Docket Number(s)	<u>50-321 AND 50-366</u>
Plant/Facility Name	<u>EDWIN I. HATCH NUCLEAR PLANT, UNITS 1 AND 2</u>
TAC Number(s) (if available)	<u>MB2886 AND MB2887</u>
Reference Meeting Notice	<u>FEBRUARY 20, 2002</u>
Purpose of Meeting (copy from meeting notice)	<u>TO DISCUSS THE 8/31/01 HATCH AMEND-</u> <u>MENT REQUEST TO EXTEND COMPLETION TIMES</u> <u>FOR INOPERABLE EMERGENCY DIESEL GENERATORS</u>

**Diesel Generator
Technical Specifications Change**

**Concerning the March 8, 2002 Meeting with Hatch
on the LAR for a Permanent TS modification to extent CTs for LCO 3.8.1**

RESPONSE TO NRC REVIEWER'S QUESTIONS CONCERNING RG 1.177

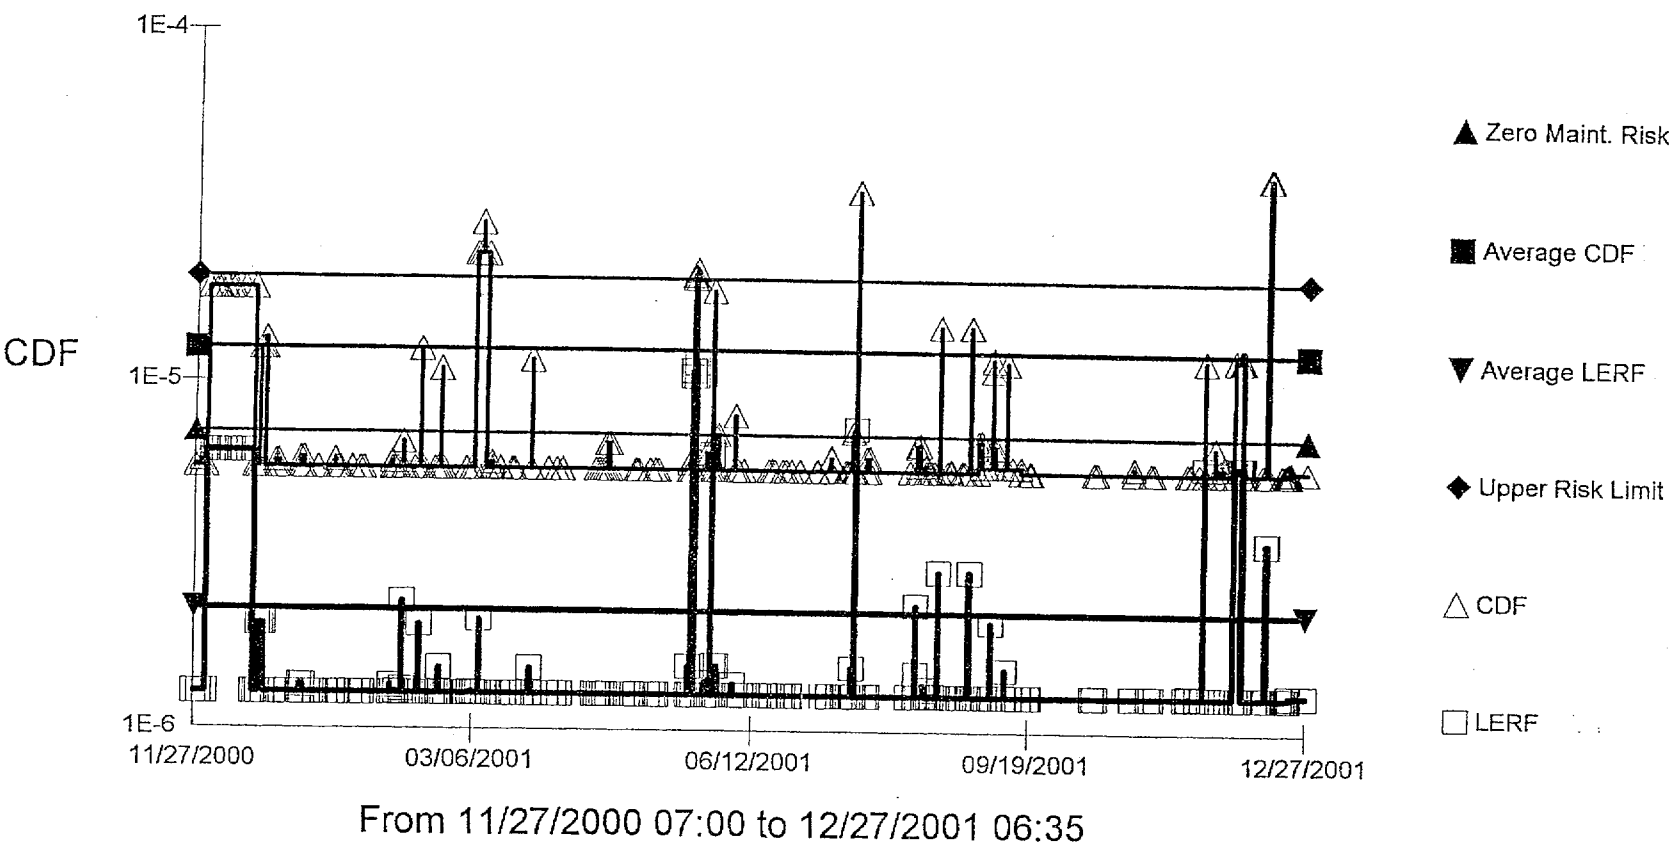
- 4) With regard to what we have been referring to as a "corrective maintenance" concern, but should be calling an "overlapping outages" issue, CRMPs provide only part of the solution. In order to be confident that the risk is manageable, the likely risk change associated with an AOT change needs to be anticipated by analysis of the proposed AOT in terms of outages of other risk significant equipment. This has become important due the increase in the frequency and length of preventative maintenance outages. The only way to anticipate these risk changes is to analyze recent risk history, e.g., by evaluating the risk profile for the previous cycle. Hence, for the highest risk unit, Hatch is requested to present and discuss the EOOS risk profile for the last or current cycle and estimates of the maximum, minimum, and mean risks associated with having the EDG out of service during the cycle for the proposed AOT.

Question 4.

Unit 1 will be used in response to this question, Unit 2 has come out of an outage within recent months.

Work evaluations are made using the Plant Hatch on-line risk monitor tool: EOOS. These evaluations cover the time frame from November 27, 2000 to December 29, 2001. The following numbers are provided as a result of the EOOS evaluation. A value of $1\text{E}-09$ was used in the EOOS calculations as a cutoff frequency limit as well as in the PSA average risk model calculations.

1 Plant Service Water pump maintenance,

2 Traveling Water Screen design modification and the C Diesel Generator maintenance,

- 3 RHR pump maintenance,
- 4 Diesel maintenance,
- 5 RCIC maintenance, and
- 6 Removal of the control room ventilation purge capability.

The following information estimates the maximum numbers for a diesel outage superimposed on selected frequency peaks from profiles **B** and **C**. The risk peak on profile **B** point 3 is approximately 3.5 E-05 instantaneous CDF. Assuming the C diesel generator is out of service at this time the instantaneous EOOS value is 1.79 E-04 . As a note this particular condition will require a short term shutdown LCO.

LERF profile **C** point 2 accounts for the C diesel being inoperative during the time of traveling water screen design modifications. The risk peak on profile **C** point 2 is approximately 1.06 E-05 .
